PLANNING COMMITTEE

19th August 2015

ADDITIONAL PAGES

Additional Representations on Schedule Items

SPITFIRE BESPOKE HOMES. SITE PLAN - LEVELS. SCALE 1/500 @ A2. DRAWING 1596-23

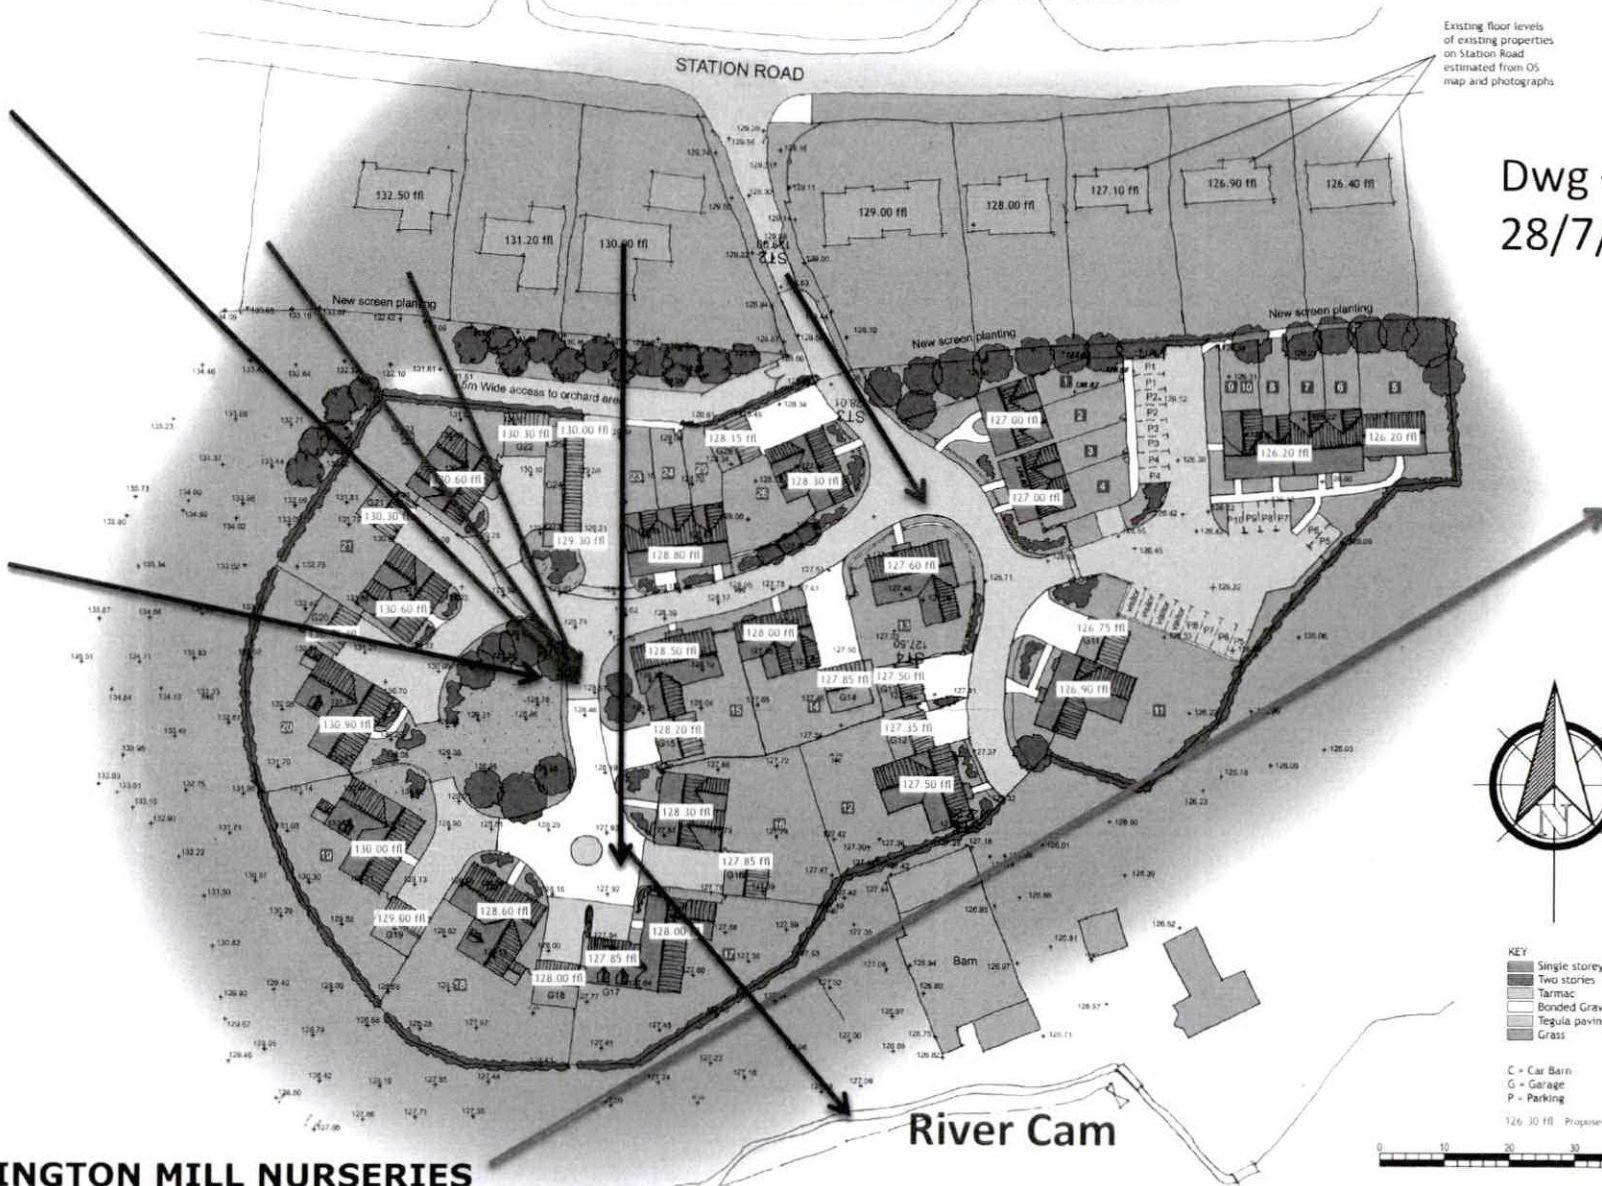
- **I object to the proposed ffl levels as being far too intrusive to all the existing houses on the south side of Station Road.** The levels drawing reveals that the majority of the dwellings will have a floor level almost equal to the existing housing on the south side of Station Road. This appears to be against the original design concept where the dwellings were to be constructed lower than existing housing on Station Road. It is also interesting that the plans for the dwellings appear to be sketched rather than detailed, especially the furniture layouts which I consider to be totally inappropriate at this stage of the planning process and gives a false impression of size.

I could not find any detailed designs or comments for the removal and distribution of surface water as mentioned in the Outline Planning approval other than on the Levels plan which includes grass, tarmac, Tegula Paving and bonded gravel surfaces. The original outline plans identified possible locations for swales/SUDS systems as a result of the site being on a flood plain but nothing is shown on the latest drawings. As an example of my concern regarding drainage may I direct you to plot 22 as the land falls approximately 4m from the boundary (grass) to the bonded gravel surface by plot 15. It is possible that owners may not wish to retain grass within their plot thus affecting the disposal of surface water in the future. Currently surface water is absorbed before reaching the River Cam valley but this development could create future flooding problems further east in the location of the Sewage Works and the fields surrounding them.
